To: T10 Committee (SCSI)

From: George Penokie (IBM/Tivoli)

Subject: SAS UML Corrections

Figure 6 — SAS domain class diagram

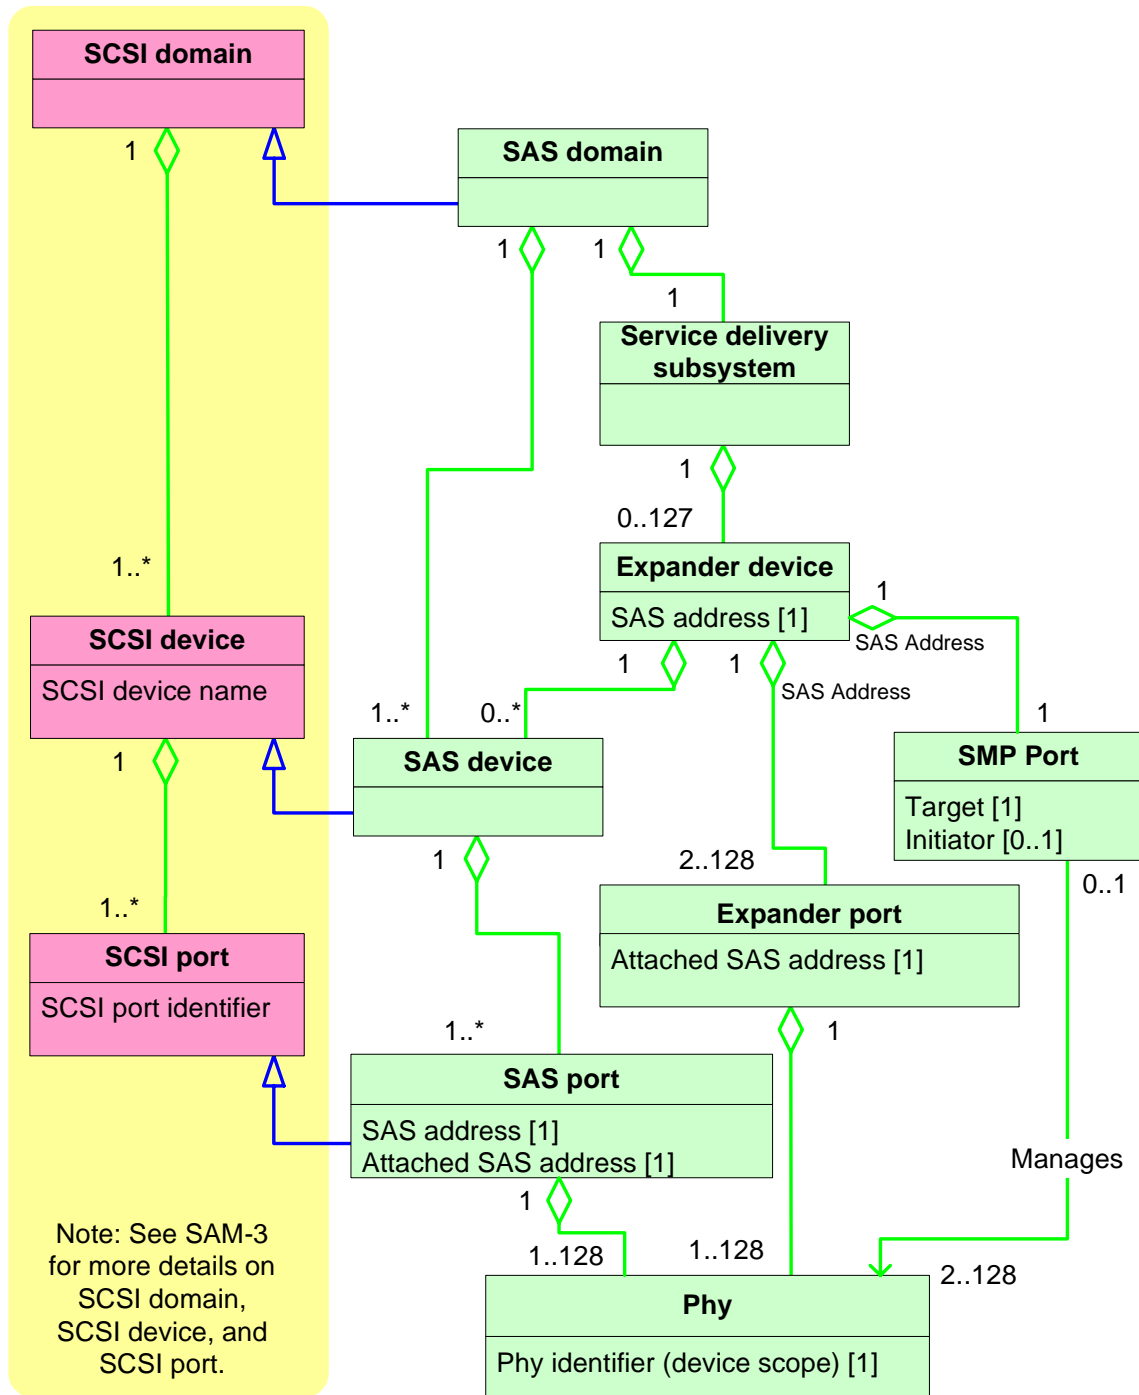
Figure 6 shows the class diagram for a SAS domain, showing the relationships between SAS domain, SCSI domain, service delivery subsystem, expander device, expander port, SAS device, SCSI device, SAS port, SCSI port, and phy classes. Relationships to ATA classes (e.g., ATA domain) are not shown in figure 6.

**Figure 7 — Phy classes**

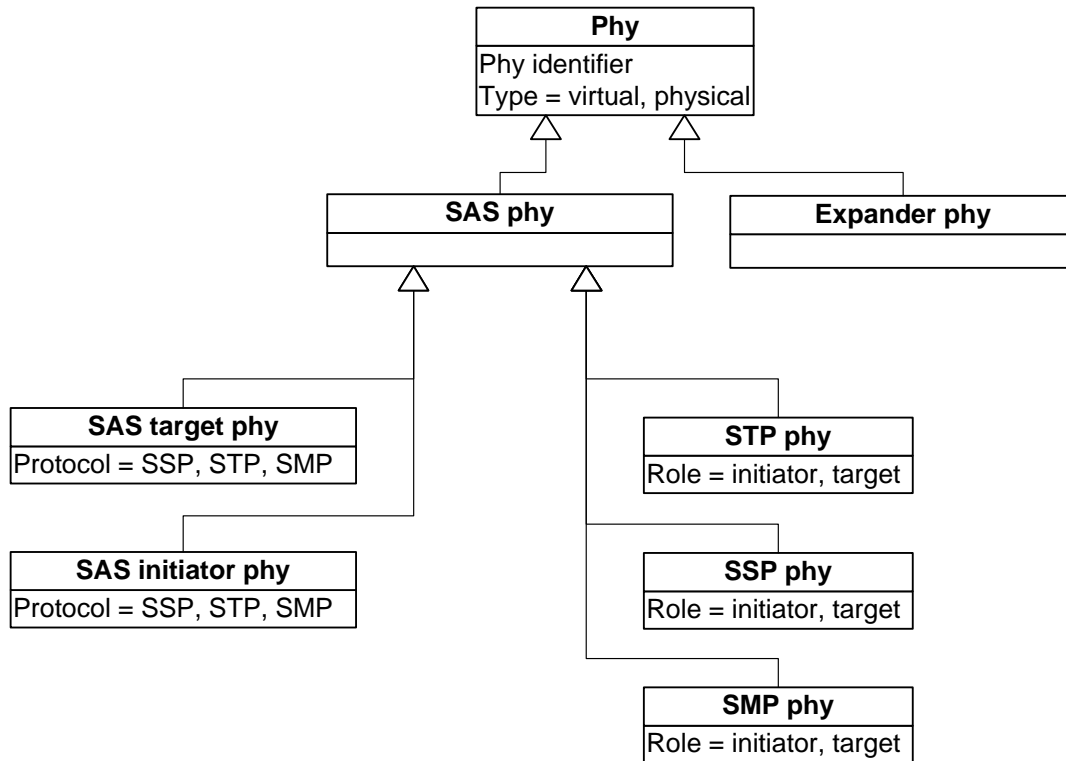
Figure 7 expands the phy class showing the relationships between the following classes:

- a) phy;
- b) SAS phy;
- c) SAS phy;

- d) SAS initiator phy;
- e) SAS target phy;
- f) SSP phy;
- g) STP phy;
- h) SMP phy; and
- i) expander phy.

Figure 9 — Port classes

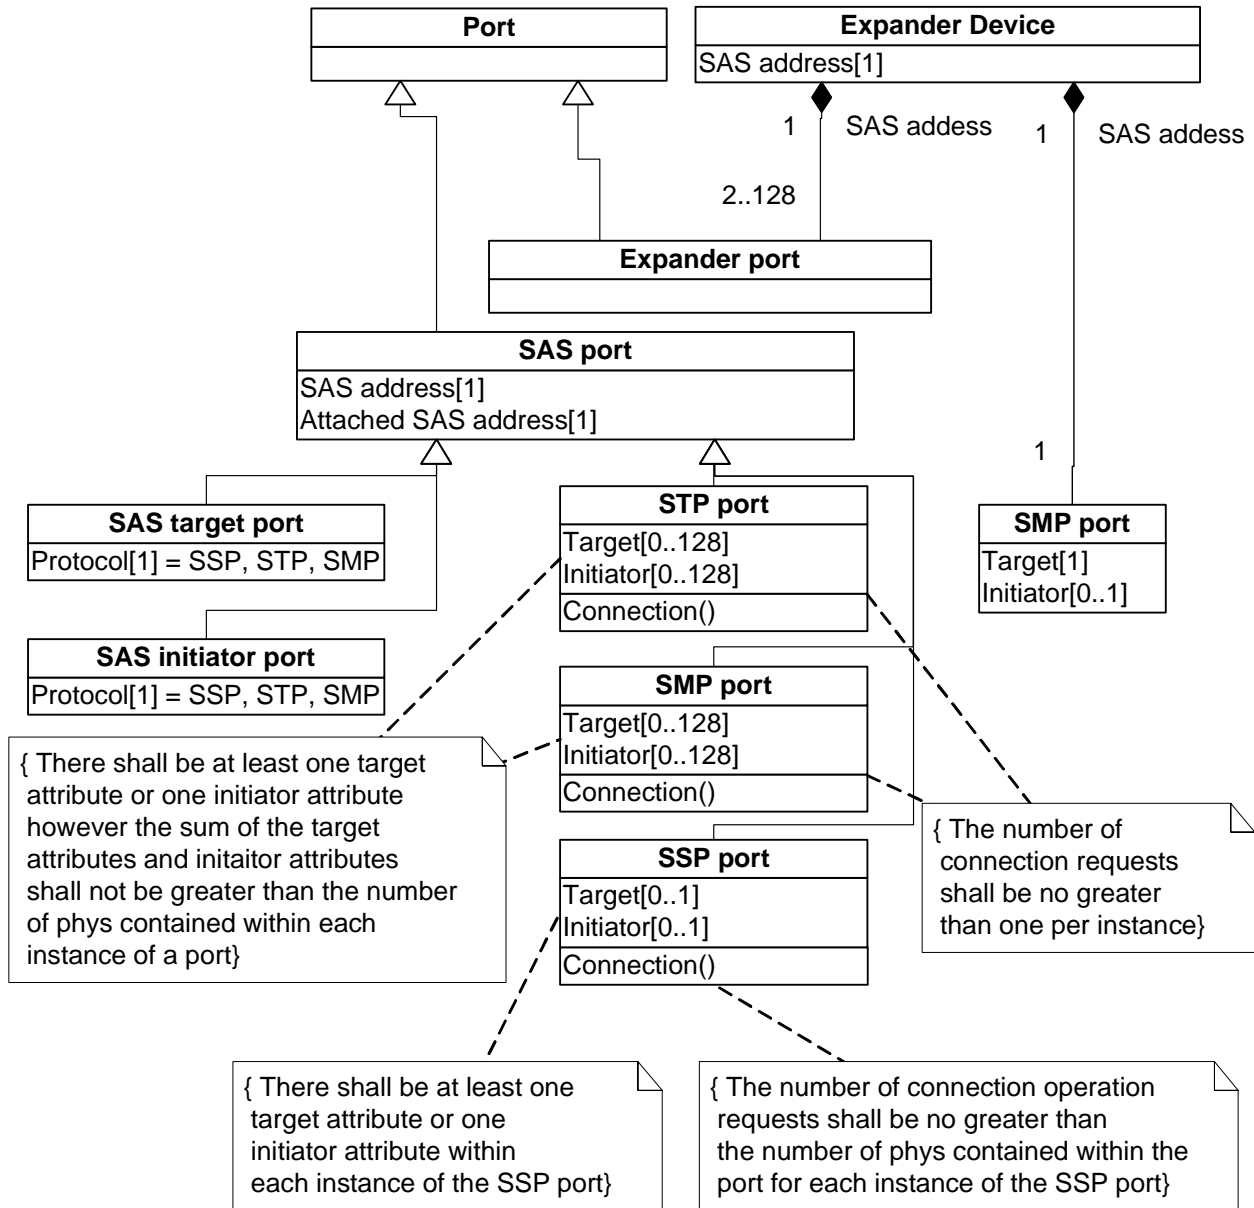
Figure 9 expands the port class and expander class to show the relationships between the following classes:

- a) port;
- b) expander device;
- c) expander port;
- d) SAS port;
- e) SAS target port;
- f) SAS initiator port;
- g) STP port;
- h) SSP port; and
- i) SMP port.

Figure 10 — Port objects

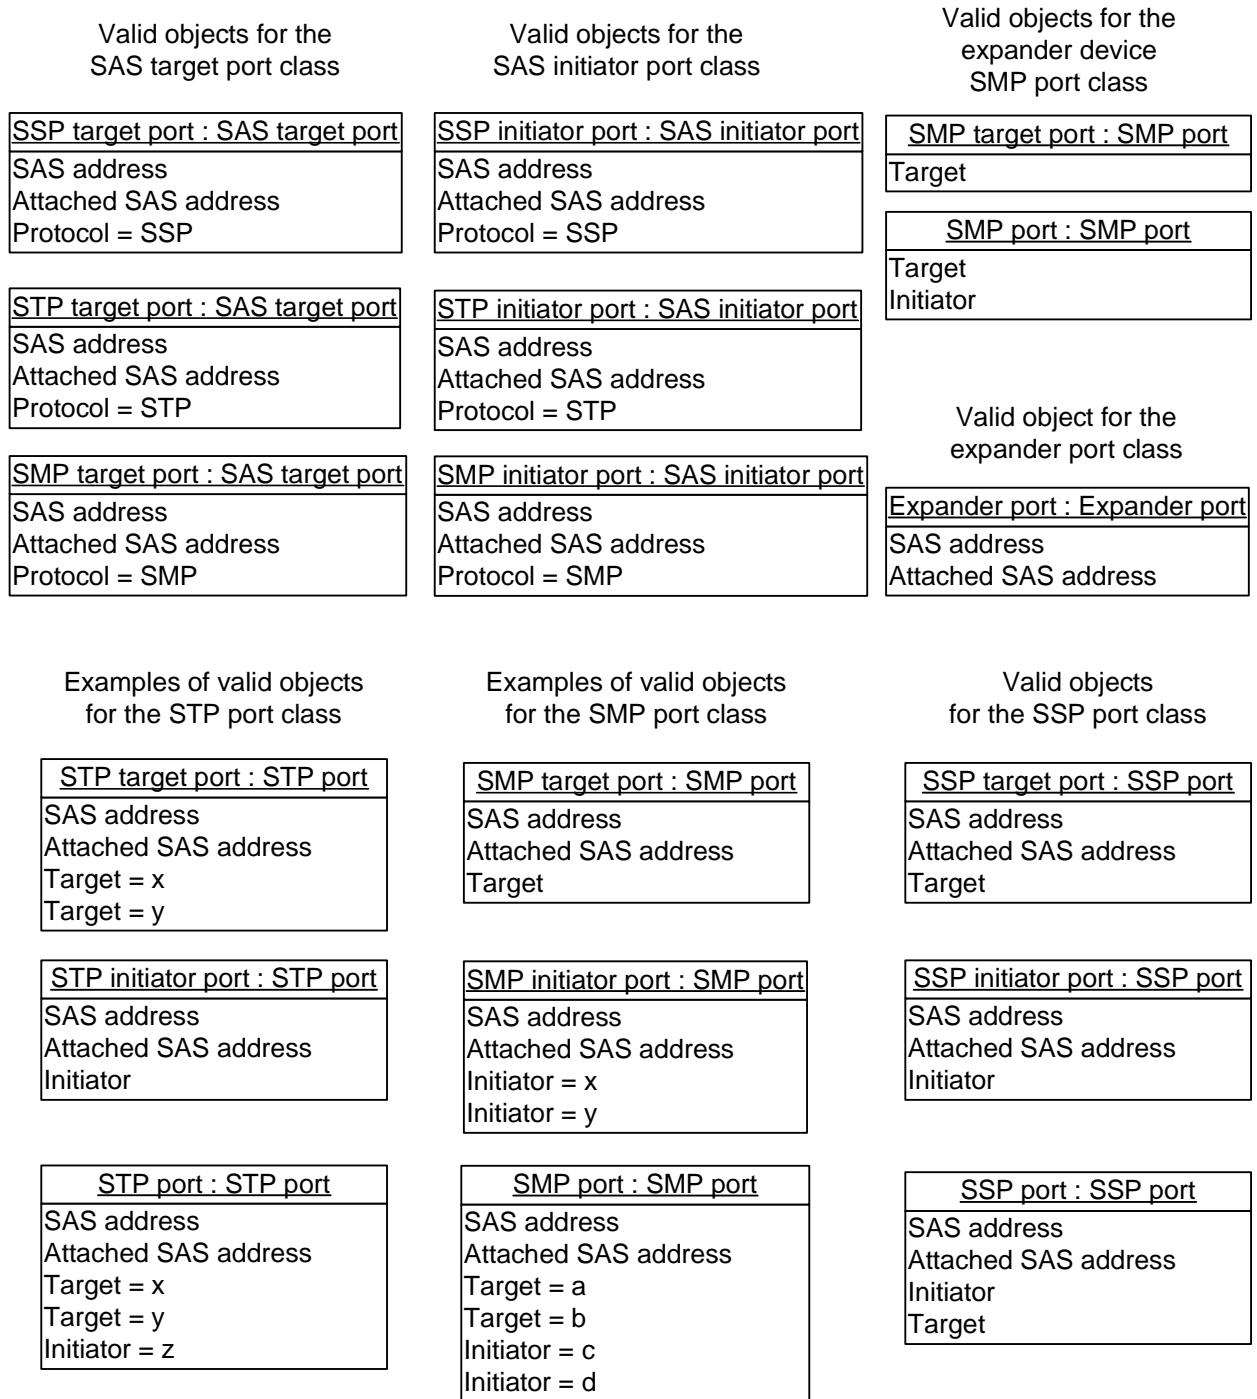
Figure 10 shows the objects that are instances of the:

- a) SAS target port class (i.e., SSP target port, STP target port, SMP target port);

- b) SAS initiator port class (i.e., SSP initiator port, STP initiator port, SMP initiator port);
- c) STP port class (i.e., STP initiator port, STP target port, STP port);
- d) SMP port class (i.e., SMP initiator port, SMP target port, SMP port);
- e) SSP port class (i.e., SSP initiator port, SSP target port, SSP port);
- f) expander device SMP port class (i.e., SMP target port, SMP port); and
- g) expander port class (i.e., expander port).

The objects of the SAS port class shown in figure 10 are only valid and unchangeable during a connection. A different object may be used on a different connection.

Figure 11 — Expander device classes

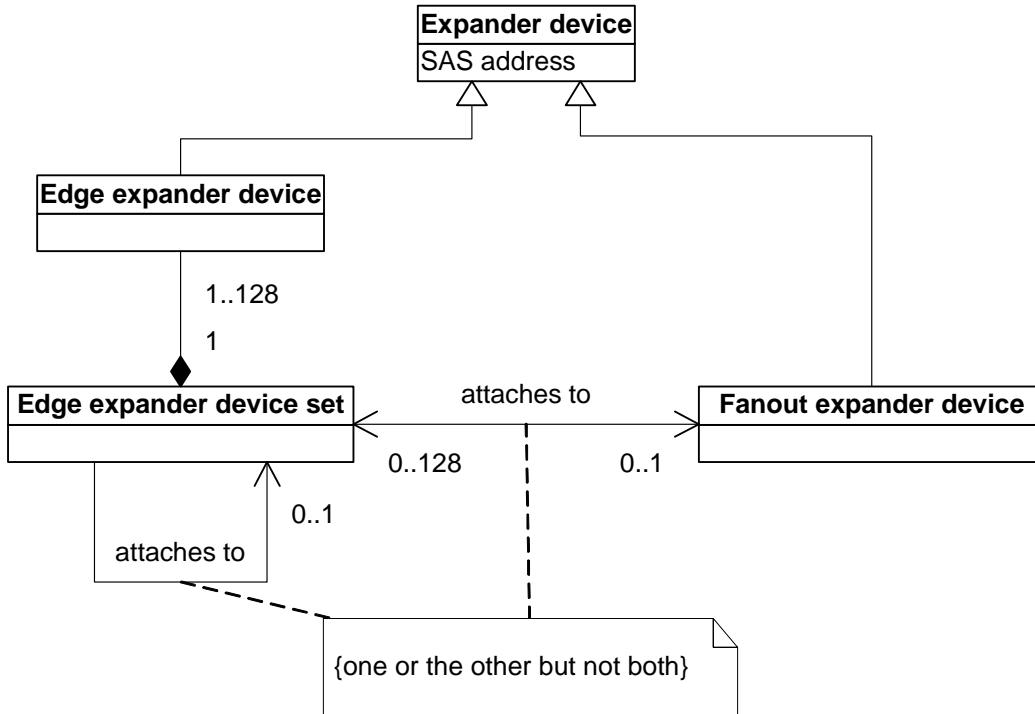
Figure 11 shows the expander device classes.

Figure 12 — State machines for SAS devices

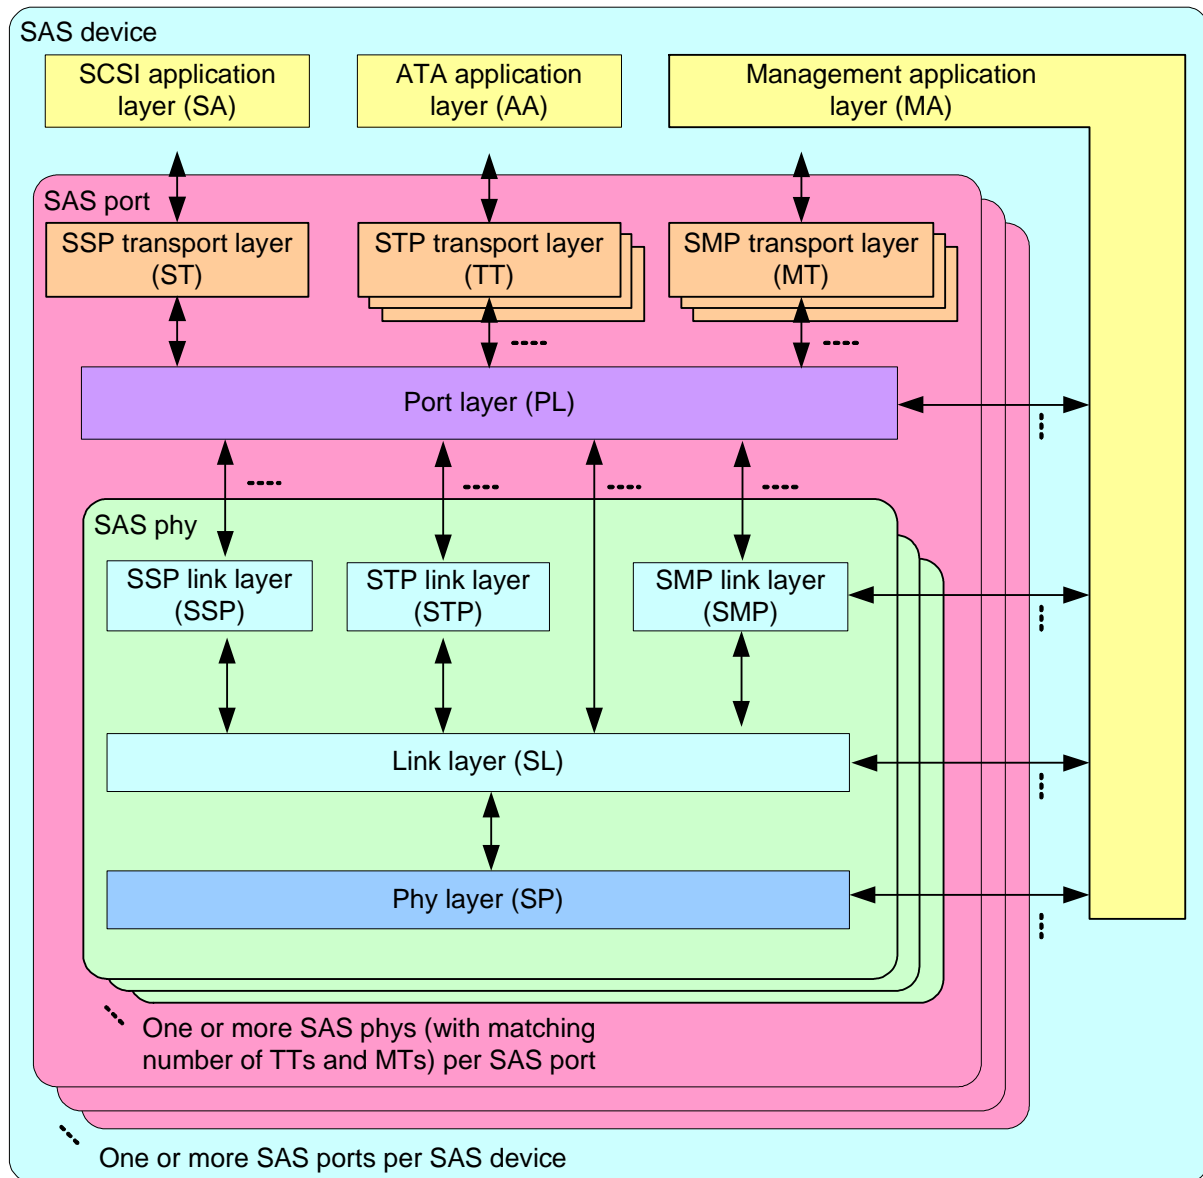
Figure 12 shows the state machines for SAS devices, their relationships to each other and to the SAS device, SAS port, and SAS phy.

Figure 13 — State machines for expander devices

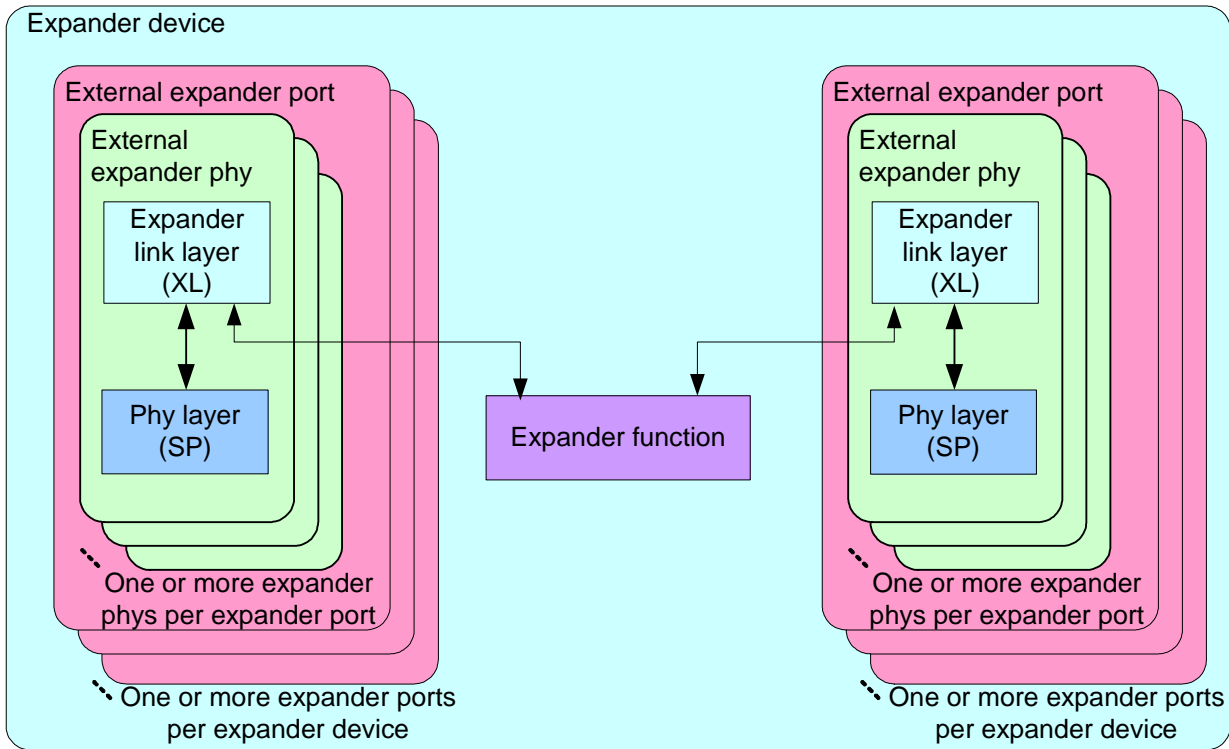
Figure 13 shows the state machines for expander devices, their relationships to each other and to the expander device, expander port, and expander phy. Expander function state machines are not defined in this standard, but the interface to the expander function is defined in 4.6.6.

Figure 14 — State machine and SAS device, SAS port, and SAS phy classes

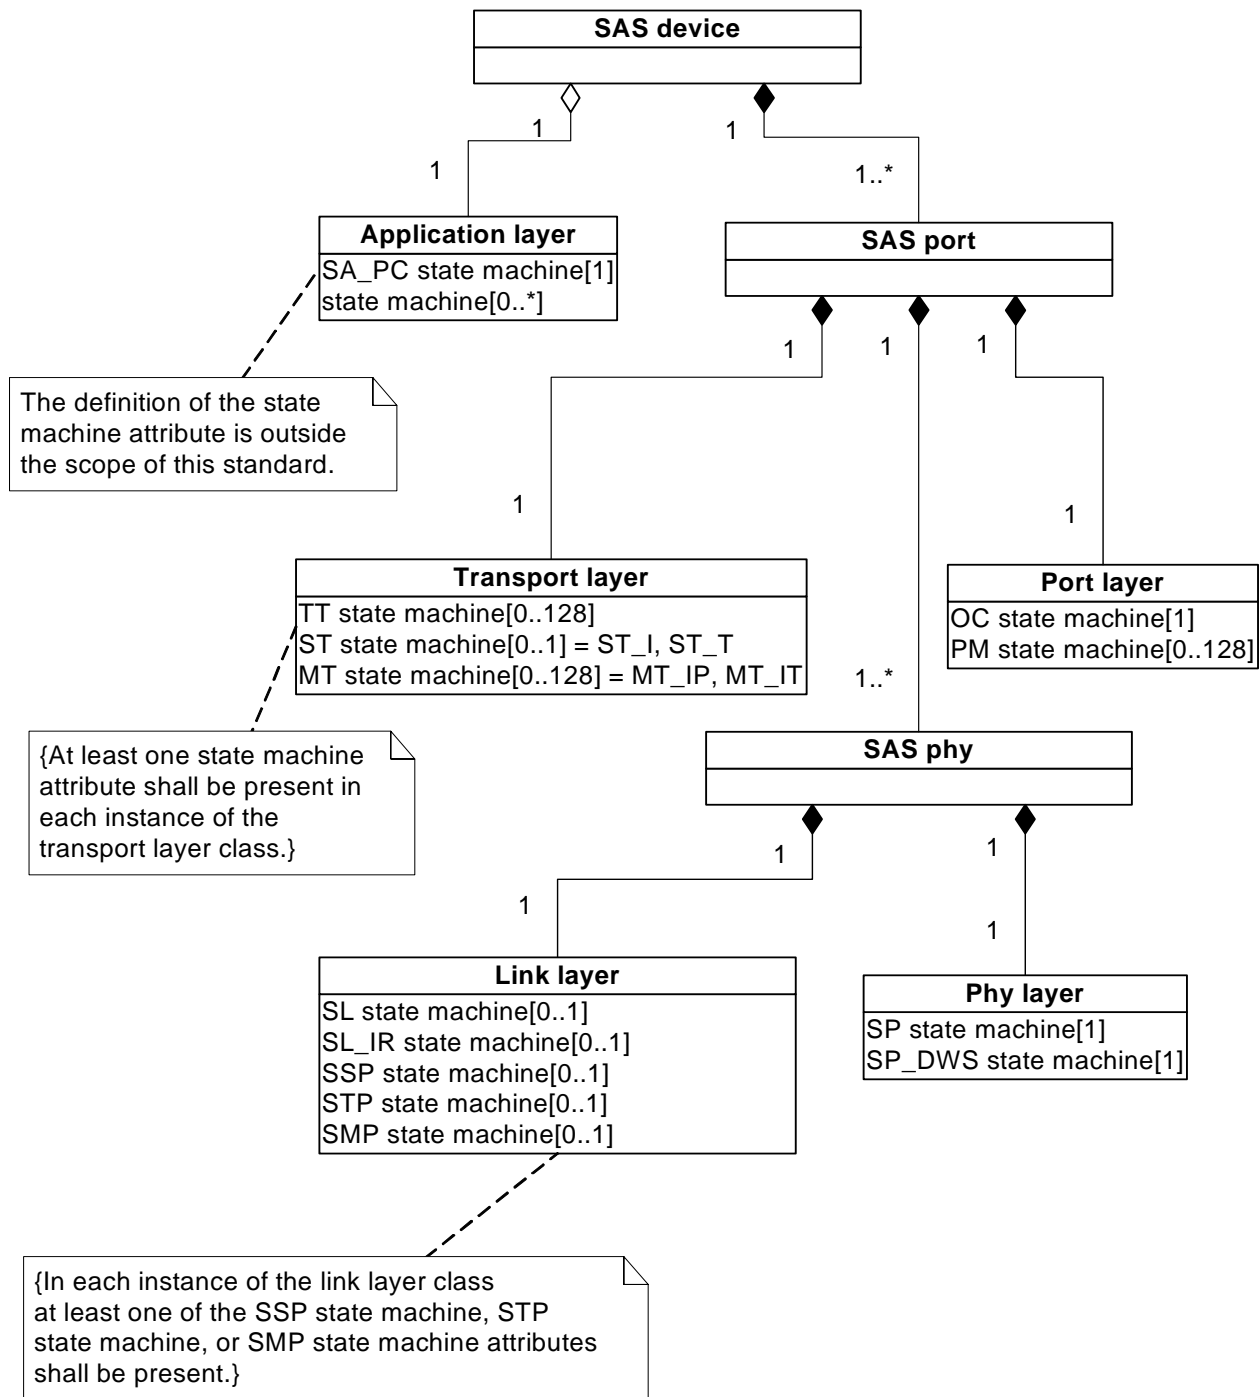
Figure 14 shows which state machines are contained within the SAS device, SAS port, and SAS phy classes.
